Copper Chase at Sterling Ranch

PUD Site Plan

PUDSP 22-002

# V3\_PUD Plan.pdf Markup Summary 6-6-2023

### Tract Exhibit

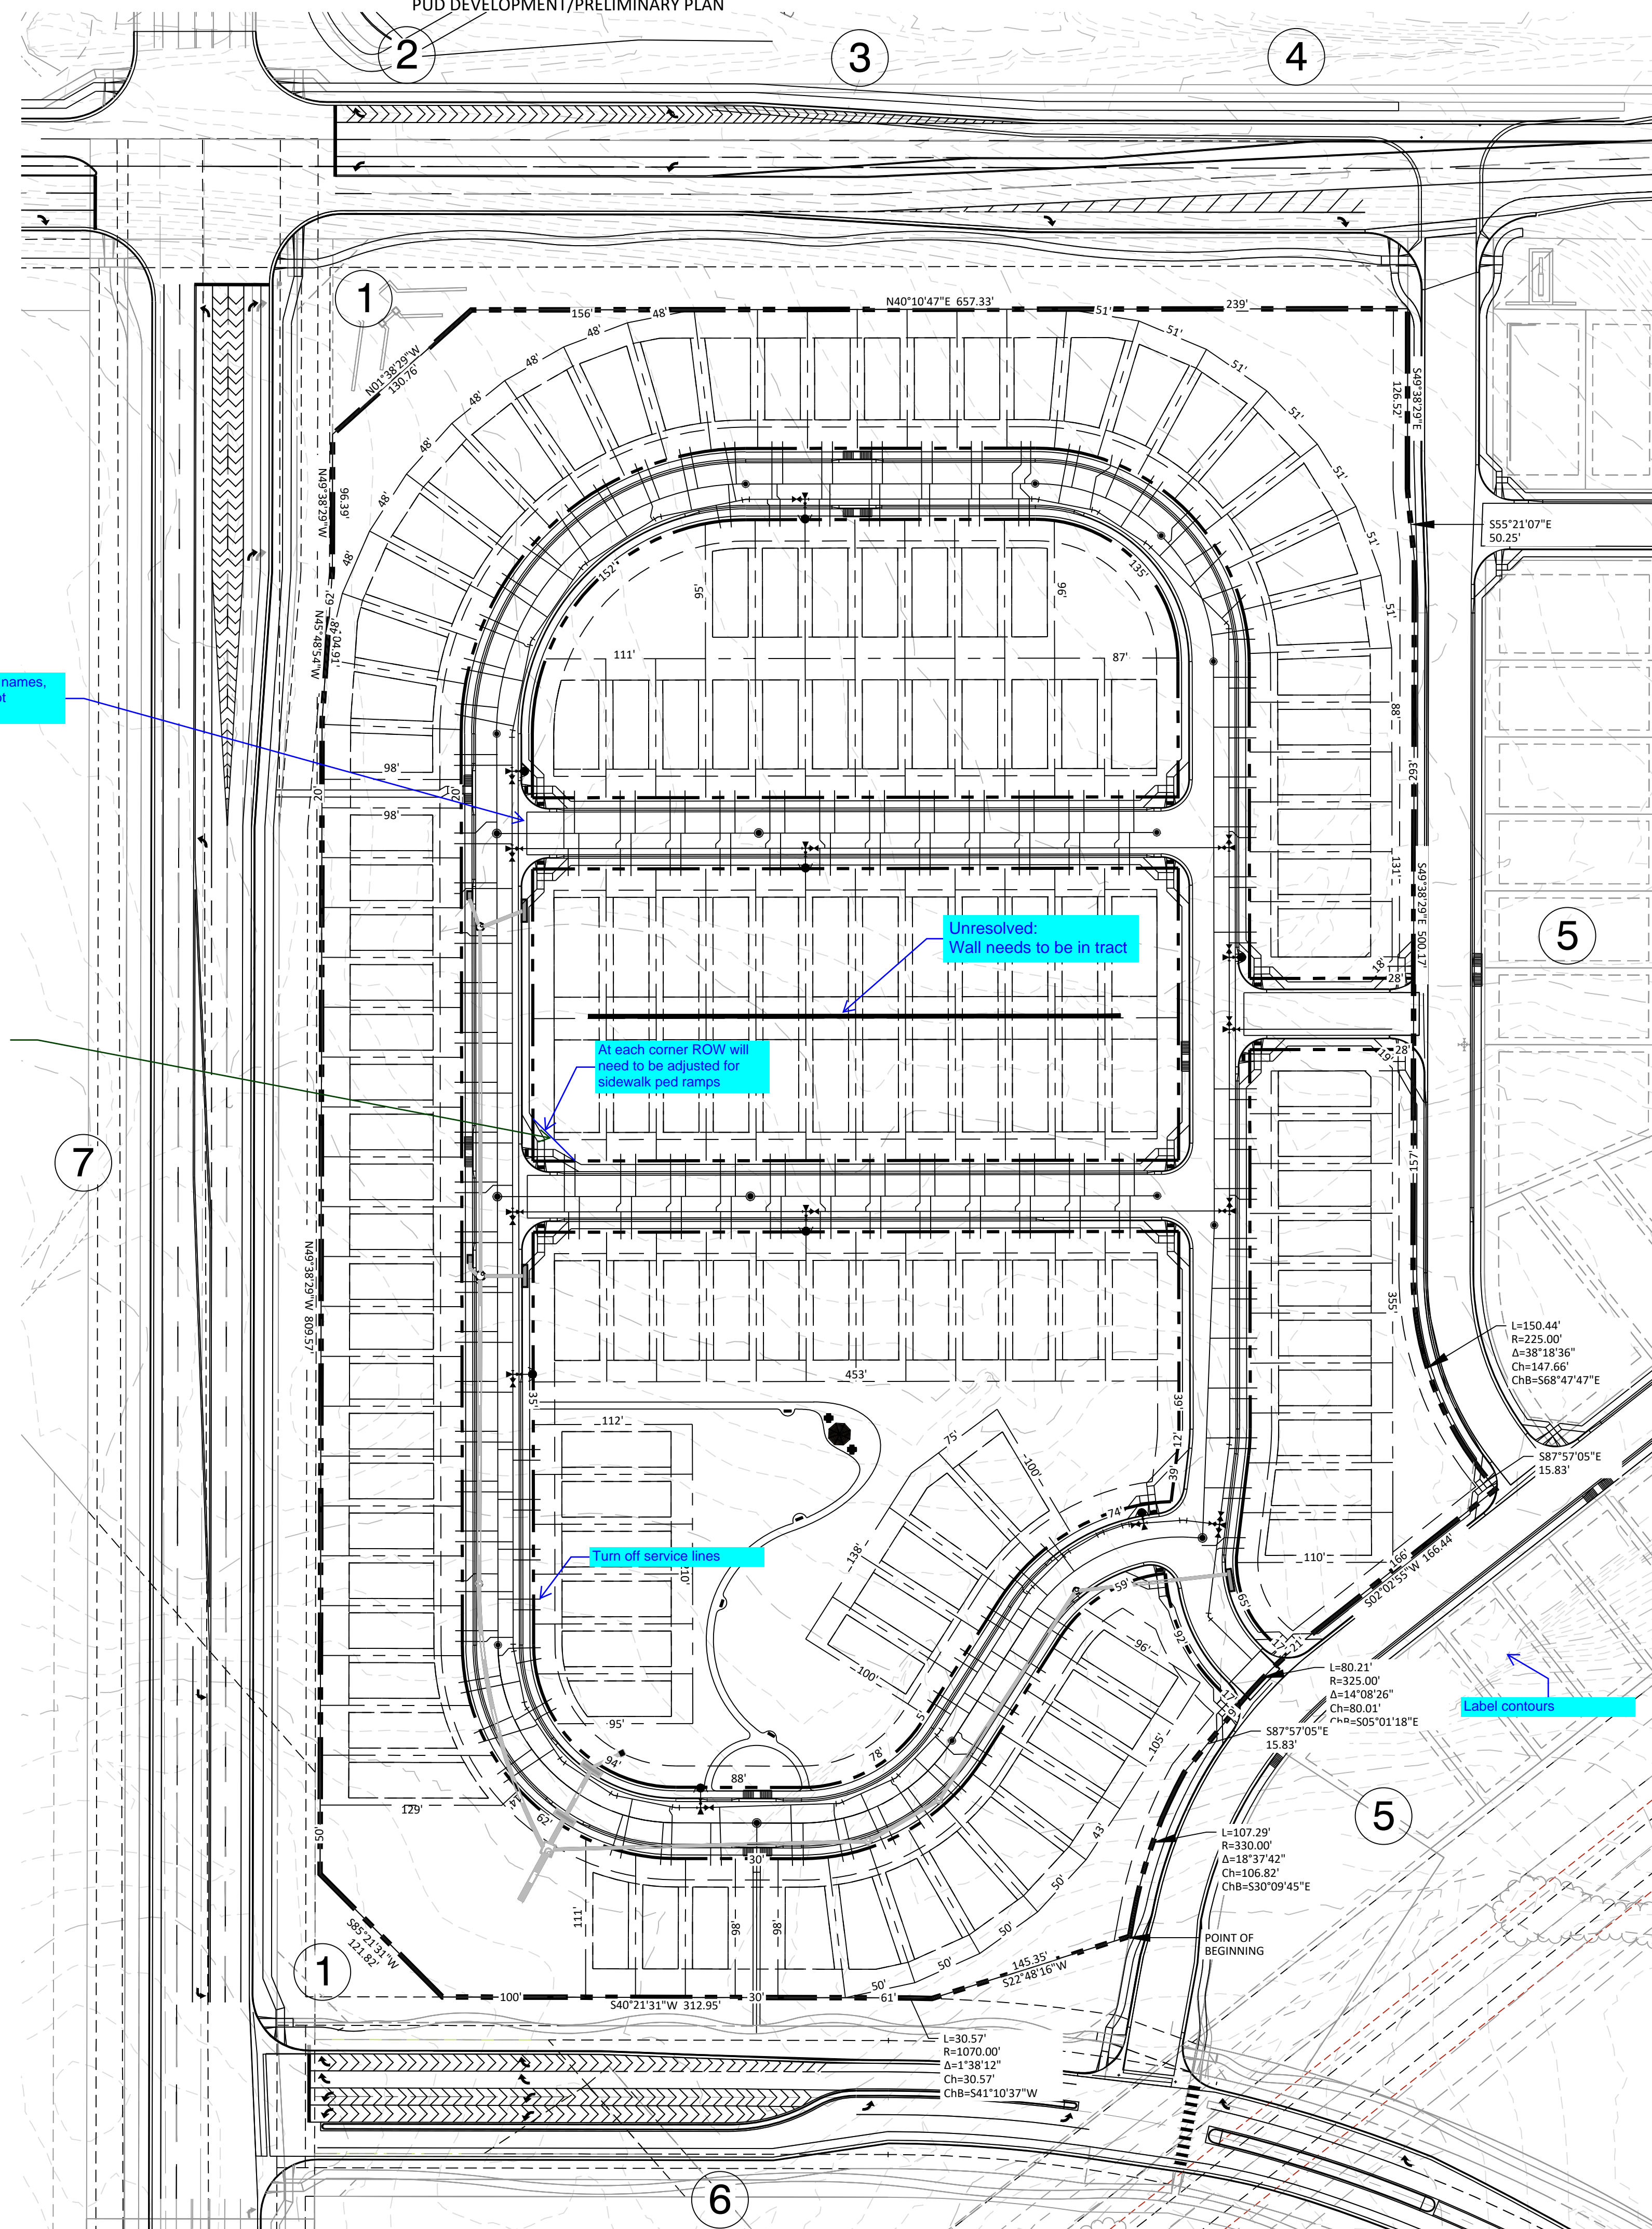
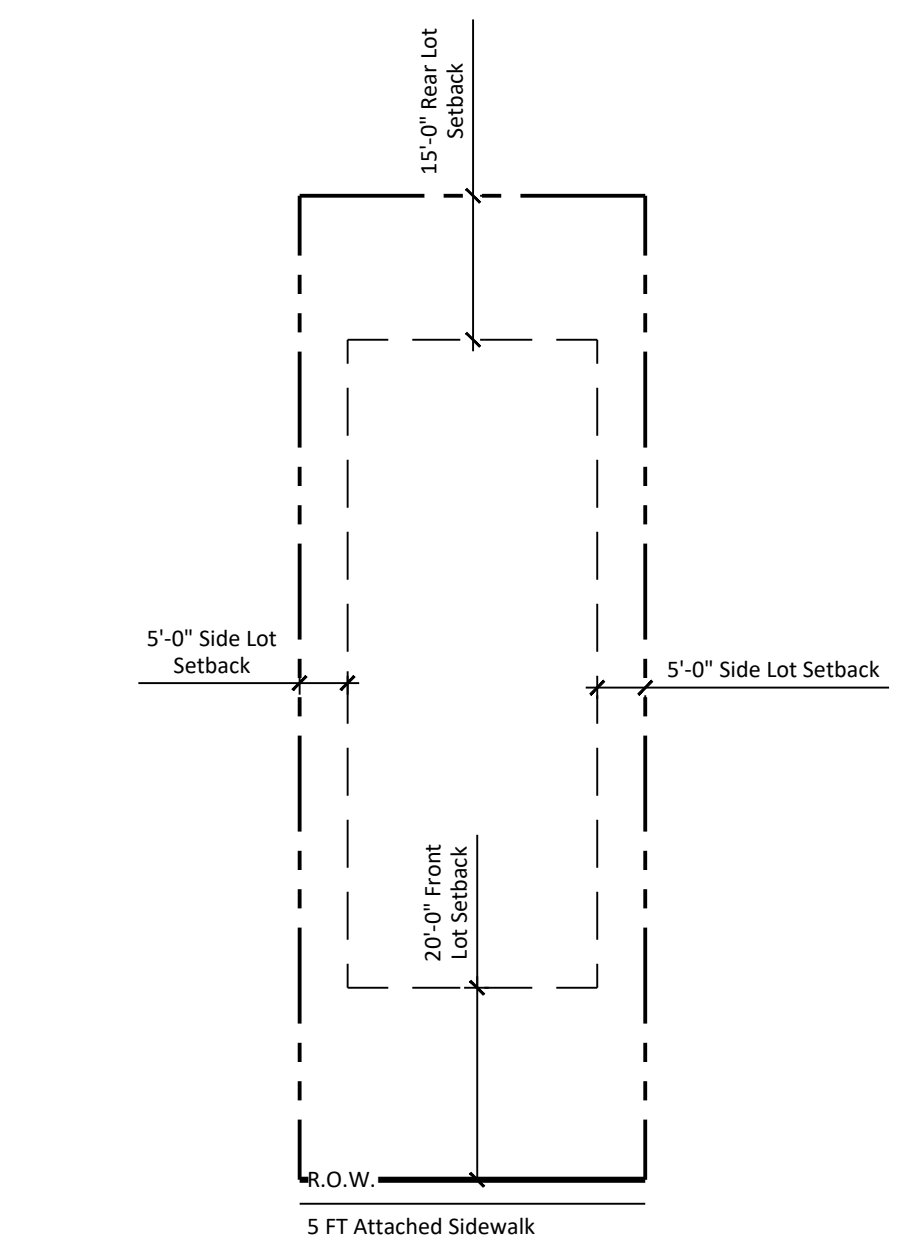
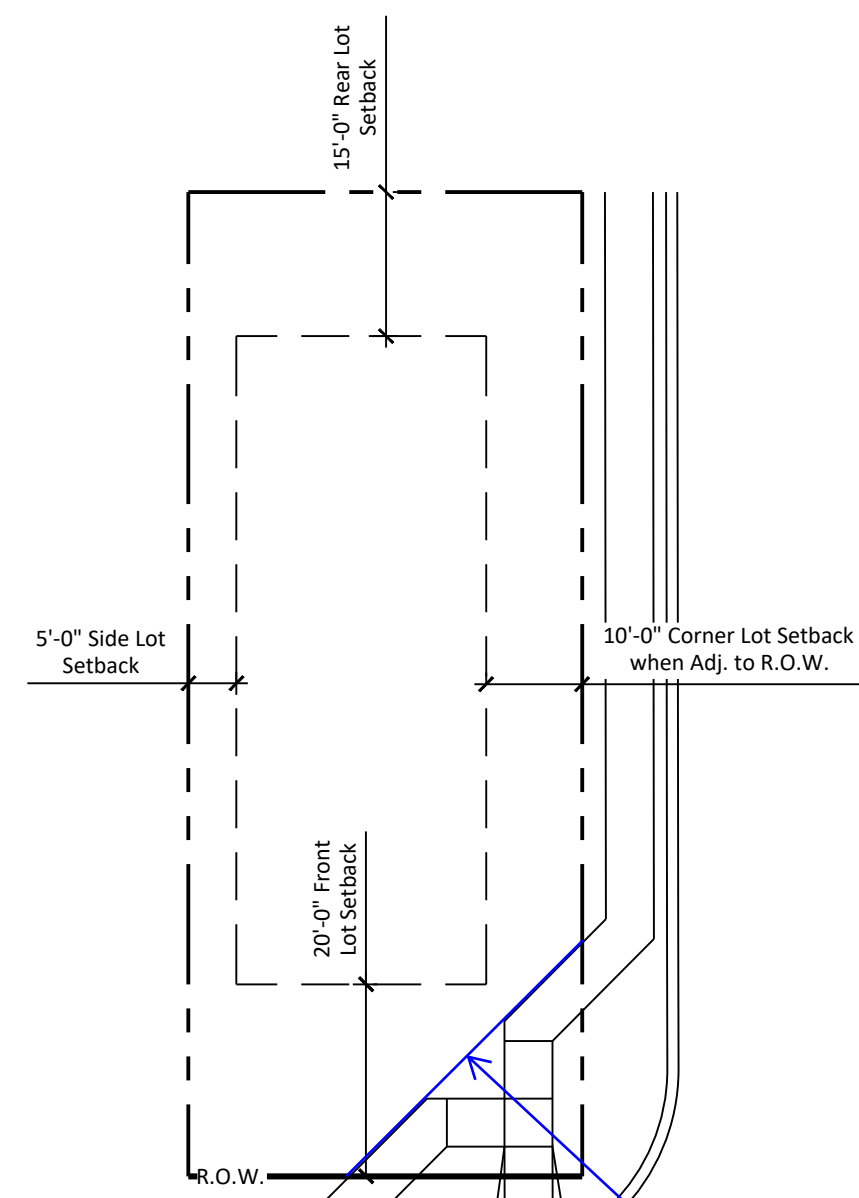
Turn on all street names, tract labels and lot numbers

clarify lot lines and dimensions so ramps and sidewalks are outside of lots

Sidewalk will need to be included in ROW
